TURKEY POINT NUCLEAR GENERATING UNIT NO. 3

AMENDMENT TO FACILITY OPERATING LICENSE

Amendment No. 57
License No. DPR-31

SAFETY EVALUATION BY THE OFFICE OF NUCLEAR REACTOR REGULATION
RELATED TO AMENDMENT NO. 57 TO FACILITY OPERATING LICENSE NO. DPR-31
AND AMENDMENT NO. 50 TO FACILITY OPERATING LICENSE NO. DPR-41
FLORIDA POWER AND LIGHT COMPANY
TURKEY POINT NUCLEAR GENERATING, UNIT NOS. 3 AND 4
DOCKET NOS. 50-250 AND 50-251

Figure 3.2-3b

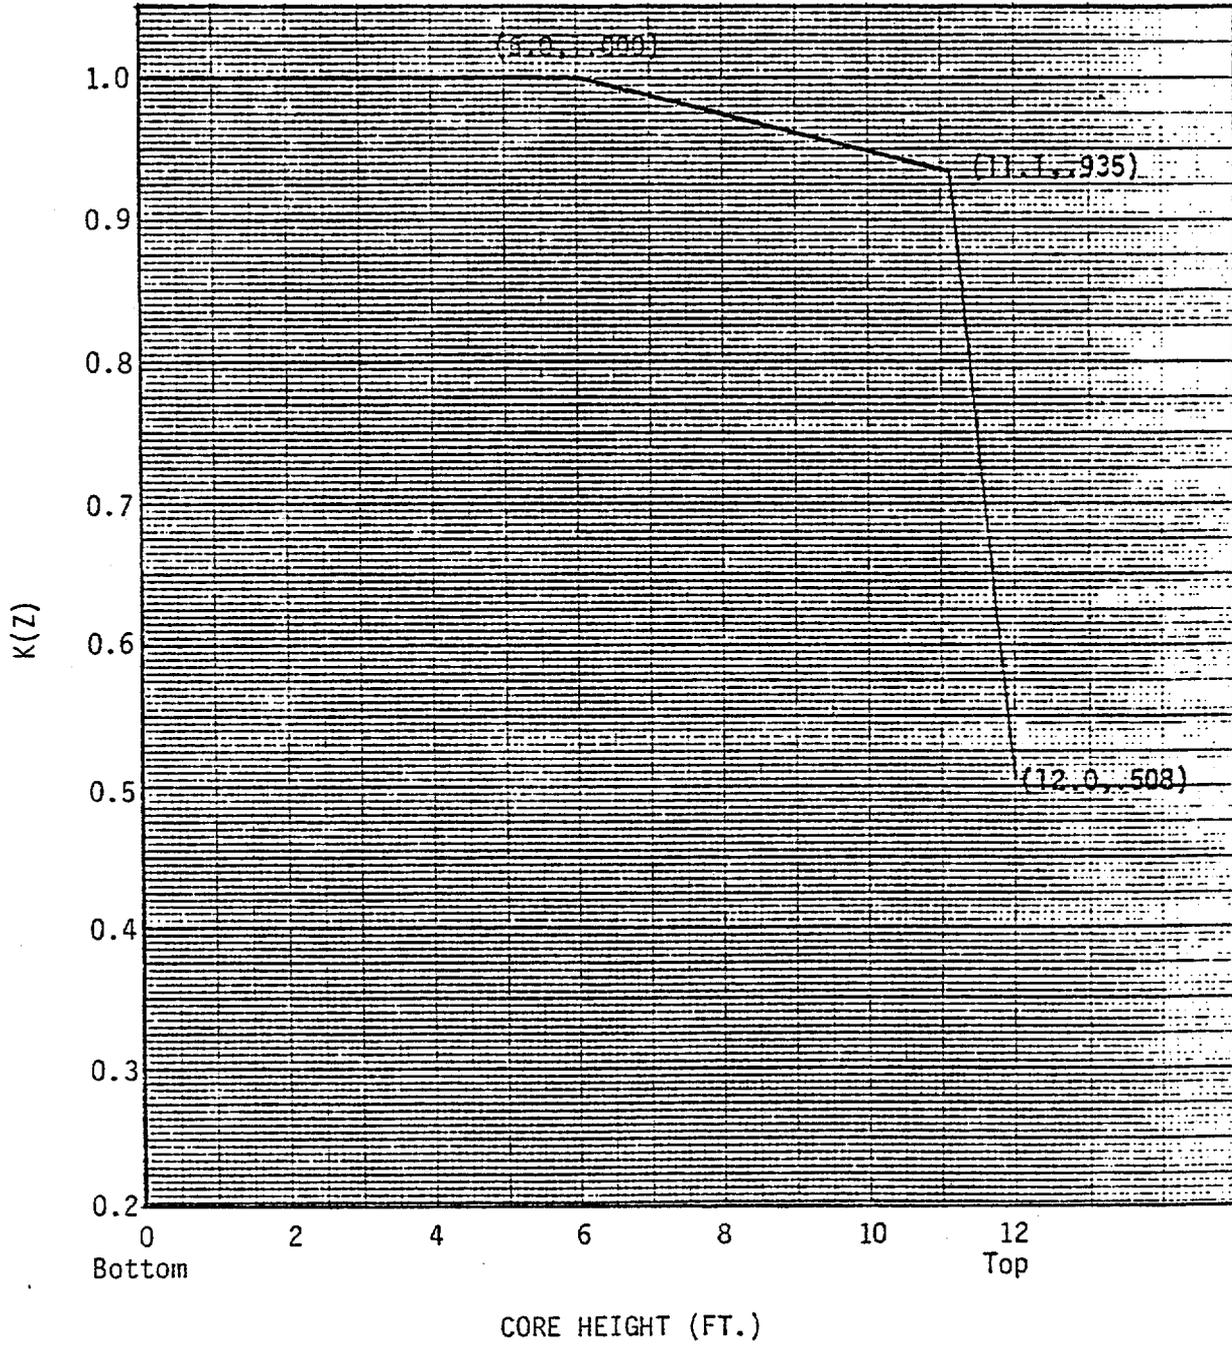
- (1) With steam generator tube plugging >22% and ≤25%, the hot channel factors (defined in the basis) must meet the following limits at all times except during low power physics tests:

Where P is the fraction of rated power at which the core is operating; K(Z) is the function given in Figure 3.2-3b; Z is the core height location of F_q .

- (a) Specification of $F_Q = 1.97$ for plant operation with 25 percent of steam generator tubes plugged.
- (b) Change of the Hot Channel Factor Normalized Operating Envelope for a steam generator tube plugging level of 25 percent (Figure 3.2-3b)

Based on the review of the submitted documents, we conclude that the results of the LOCA analysis performed with $F_Q = 1.97$ are conservative relative to the 10 CFR 50.46 criteria. We consider the resultant changes to the Technical Specifications acceptable for operating Units 3 and 4 with up to a maximum of 25 percent of steam generator tubes plugged.
